**CHIEF EXECUTIVE’S REPORT ON PROPOSED STRATEGIC
INFRASTRUCTURE DEVELOPMENT BY THE GOVERNORS OF ST. PATRICK’S
HOSPITAL FOR THE DEVELOPMENT OF A NEW MENTAL HEALTH HOSPITAL
FACILITY AT ST EDMUNDSBURY HOSPITAL, LUCAN ROAD, LUCAN, CO.
DUBLIN**

SECTION 1: INTRODUCTION

Statutory Basis and Purpose of Report

Figure 3: Figure 4-19: Encroachment of proposed works into pNHA woodland habitat (Source: Environmental Impact Assessment Report)

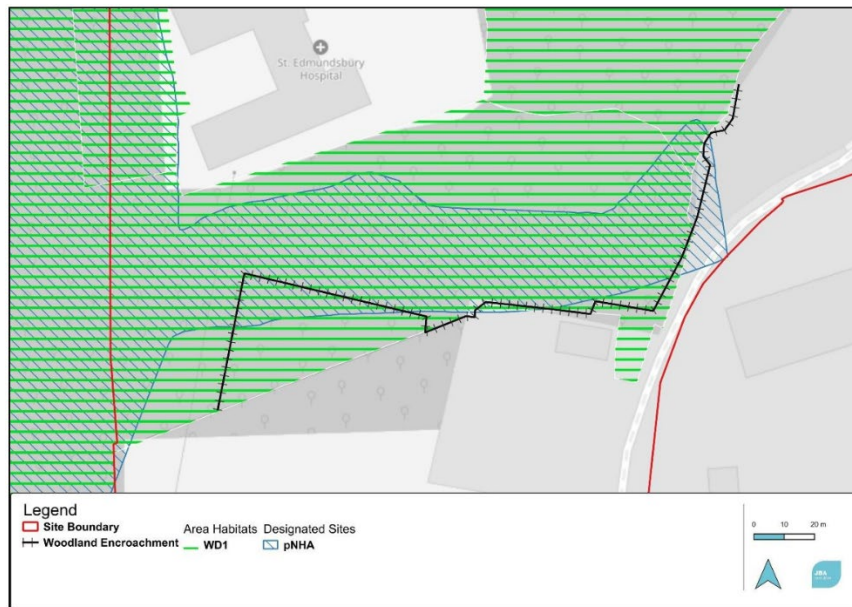
In relation to impacts of the proposed development on the pNHA, it is summarised in the Biodiversity Chapter of the EIAR that there would be *'irreversible permanent habitat loss'* and *'part of the woodland associated with Liffey Valley pNHA will be cleared and become an artificial building and surfaces, this will result in a permanent alteration of the Liffey Valley pNHA, reducing the overall woodland cover of the pNHA by roughly 1500m²'*. This report also states that there is a required clearance and maintenance 5m buffer around the building.

To address this, mitigation measures are proposed by the applicant, which include a pNHA Woodland Relocation. The appropriateness of the proposed mitigation measures is discussed further below by the Heritage Officer and Parks and Public Realm Department.

As a result, the report makes recommendations for the proposed design to be amended in order to remove the intrusion of the north-western corner of the proposed development into the regenerate woodland buffer and pNHA woodland. Additionally, the Heritage Officer report makes recommendations for the submission of a Biodiversity Management Plan, the retention and protection of existing trees and hedgerows, a more detailed assessment of potential impacts on bats and additional bat survey work and clarification is recommended to be sought from NPWS regarding the appropriate process for the application of derogation licences to disturb protected species.

Figure 1 proposed layout at the junction at Chapel Hill.

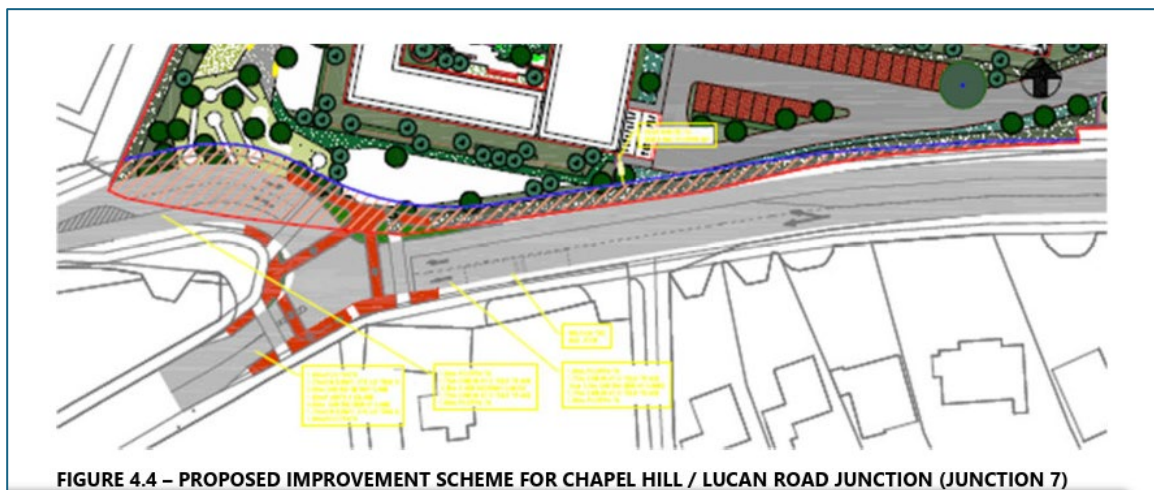
The primary access is from the Lucan Road R835. The existing road is a 9.5m wide carriage way with good pedestrian facilities on both sides. The speed limit is 50km/h and there is a weight restriction of 7.5 tonnes. There is a centre median to allow right turning into an existing access and the st Andrew's School. A bus lane begins 60m west of the entrance.

Figure 2 Access Junction.

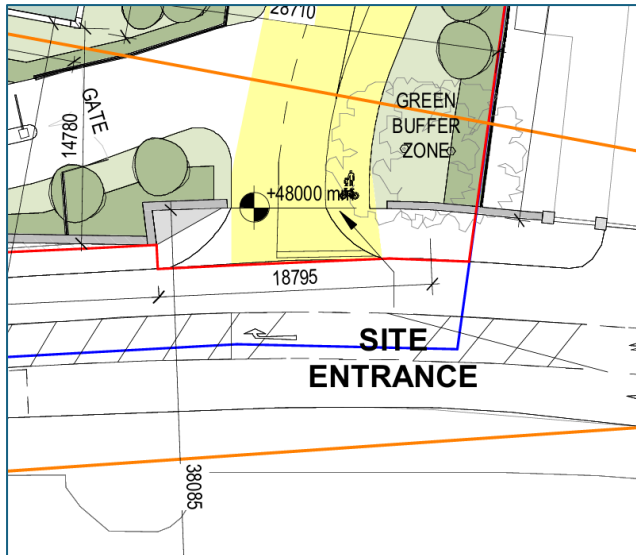
The existing access to the hospital will be altered with new corner radii and overall width. The existing access is 5.717m wide. The proposed access will be 6.5m for vehicles and a 3.0m walking path. The overall access will be excessive at above 11.0m particularly for pedestrians to cross. The design should prioritise pedestrians and should conform to DMURS standards for corner radii and pedestrian crossing. The boundary walls at the access will be kept at the original height of 1.66m.

There is a right turning arrow for vehicles entering the development, but there is no direction or line marking for vehicles exiting and wanting to turn right. The access is very close to the entrance to the school at 20.0m. There should be adequate visibility splays in both directions considering the low speeds of the R835, but the applicant should provide the vision lines on a layout. There are proposals to move the bus stop closer to the Chapel Hill Junction, the applicant shall consult with the TII on the best possible location for the bus stop. The current proposal is too close to the traffic lights and may result in reckless overtaking at the junction by drivers.
